Zoning Board of Appeals Meeting of August 12, 2026

Application No. PUD-2026-012 GDP & SIP

Applicant: Wayne Lensing

Requested Actions: PUD, Planned Unit Development for the construction of a new building to expand the existing museum use.

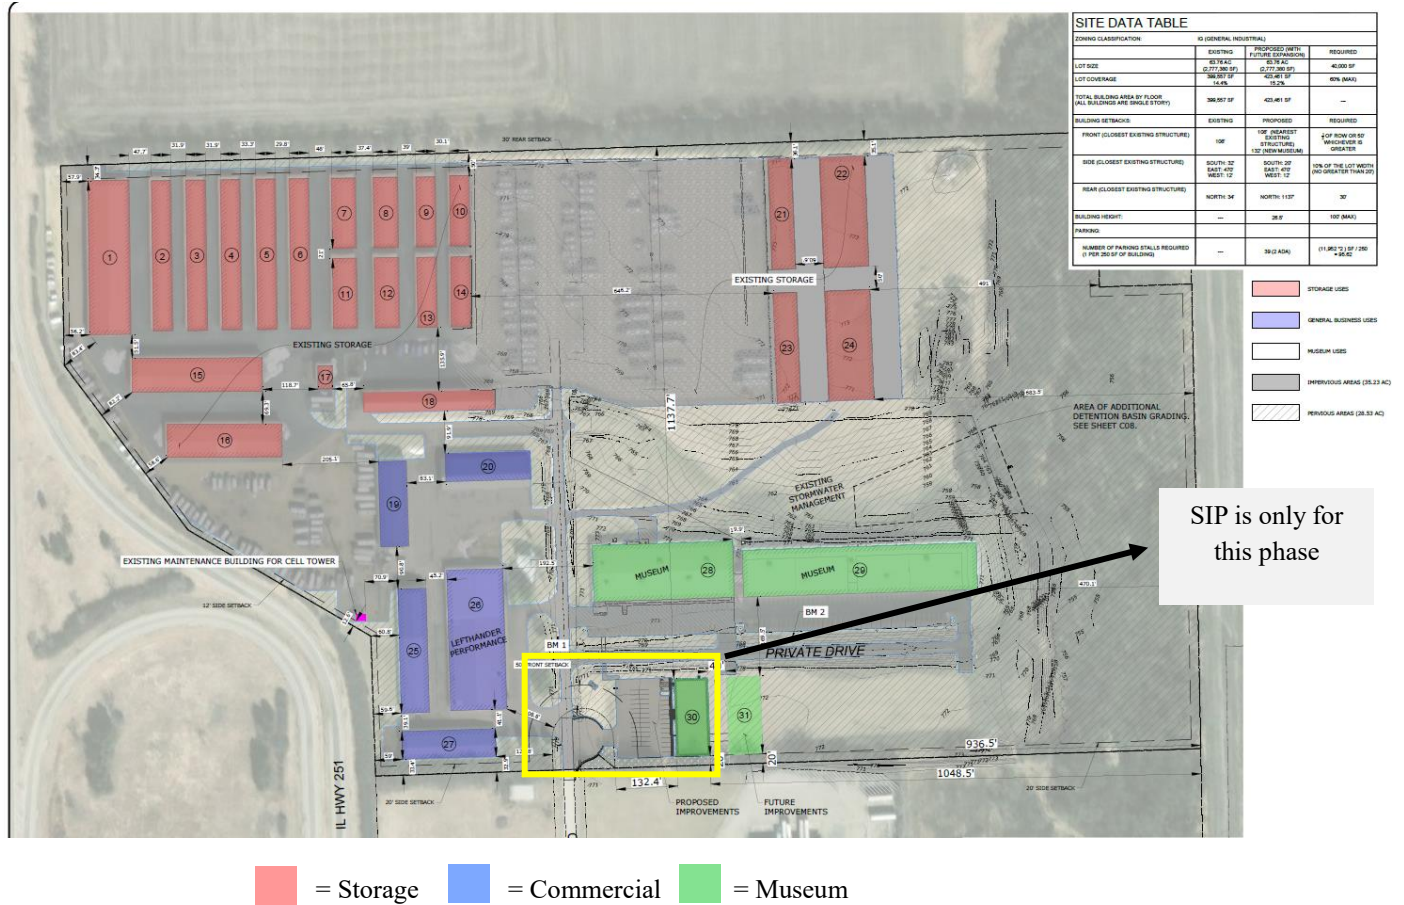
The subject property currently contains 29 buildings. The applicant is proposing the construction of Building 30, which will serve as a Fire Truck Museum. The General Development Plan (GDP) also identifies a future Building 31, located behind Building 30, as a planned museum addition. Building 31 is not included in the current Specific Implementation Plan (SIP) request.

Proposed Site Plan

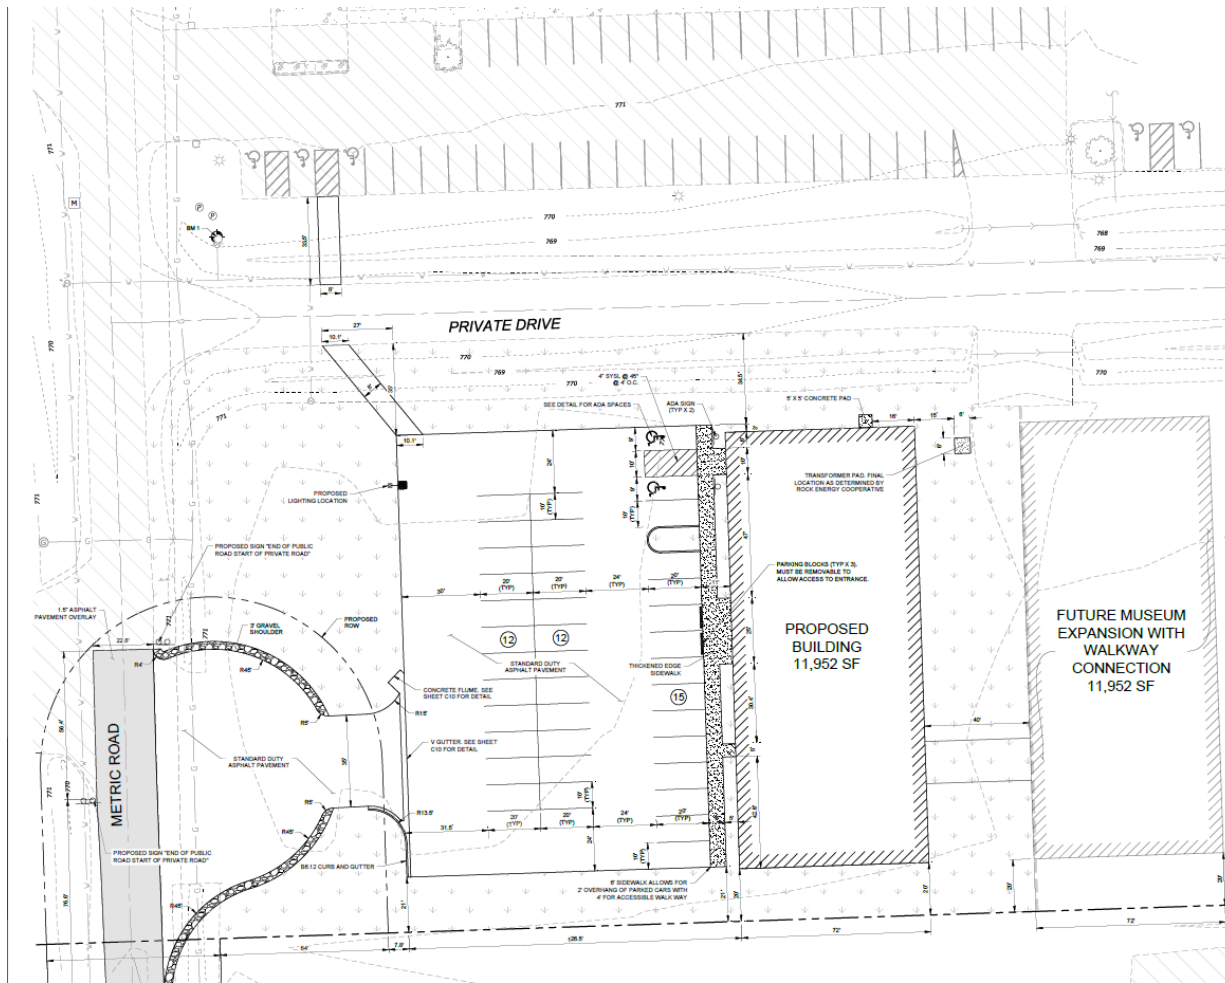
Parking Lot Design and Layout: Access to the site will be provided from Metric Road and a new dedicated cul-de-sac, in compliance with the annexation agreement. Wheel guards are required for parking spaces adjacent to sidewalks, pedestrian circulation areas, or landscape areas so that no part of a parked vehicle will encroach, but are not required for interior stalls. The applicant has asked to thicken the sidewalk along the front facade of the building instead of providing wheel stops. Engineering has agreed that this meets the intent of the code.

The proposed parking lot will be surfaced with asphalt, and the parking stall dimensions and drive aisles comply with the Zoning Ordinance. The parking stall width has been increased from 9.5 feet to 10 feet, and the drive aisles range from 24 feet to 31 feet in width, meeting and exceeding applicable code requirements. The reduction in paved area and corresponding increase in setback areas do not create any zoning compliance issues and are consistent with the requirements of the Code.

Pavement surface striping should define each parking space, and shall be a minimum of four inches in width from the length of each space. Striping for each parking space shall be painted yellow or white. Thermoplastic pavement markings are an acceptable alternative. A 5-foot-wide concrete pedestrian access has been added from the existing Museum parking lot to the new proposed parking lot to improve on-site circulation.

Section 15-619 of the Zoning Code regulates off-street parking requirements. Museum land uses require one off-street parking stall per 250 square feet of building. Based on the size of the proposed building, 48 off-street parking spaces are required. The proposed site plan provides 38 parking spaces, including two ADA-compliant accessible spaces. The applicant stated the combination of the existing parking available throughout the site and the 38 spaces proposed for the museum will provide adequate parking to accommodate the anticipated demand for the addition.

The updated plans removed two interior landscape islands, each measuring 9 feet by 18 feet, that were previously located along the ends of the continuous double rows of parking. The applicant is requesting flexibility from this requirement.

- Off-Street Parking: Approval of the proposed off-street parking count, including the provision of 38 parking spaces for Building 30, as proposed on the SIP.
- Parking Lot Landscape Islands: Approval to omit interior parking lot landscape islands within the parking lot serving Building 30, as proposed on the SIP.

1. The applicant shall obtain all required state, county, and local permits and approvals before commencement of work.
2. The applicant shall provide a thickened concrete sidewalk adjacent to the parking area along the front façade of Building 30 to serve as a durable vehicle stopping edge in lieu of wheel stops, as approved by the Village Engineer.

3. The parking lot shall be striped in full compliance with all applicable code requirements.
4. All proposed signage shall comply with the applicable sign regulations of the IG, General Industrial zoning district.
